City Council Public Hearing

Unified Development Code (UDC) Policy Amendments

October 2, 2025

Cul-De-Sac Exception Example

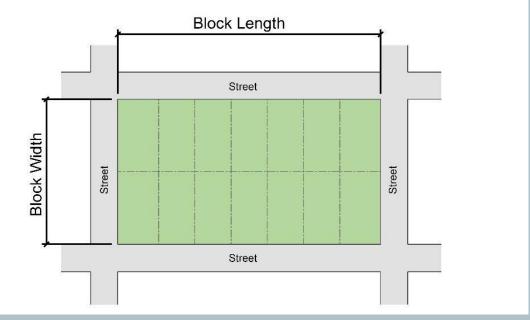
What is the problem: Lots served by private well and/or private septic are required to have a minimum street frontage of 150 feet or 200 feet. Clarification is needed regarding minimum street frontage along cul-de-sacs.

Proposed UDC Amendment: The minimum street frontage was reduced to 100-feet for lots on a culde-sac or knuckle-sac, which will allow four lots on a standard cul-de-sac.
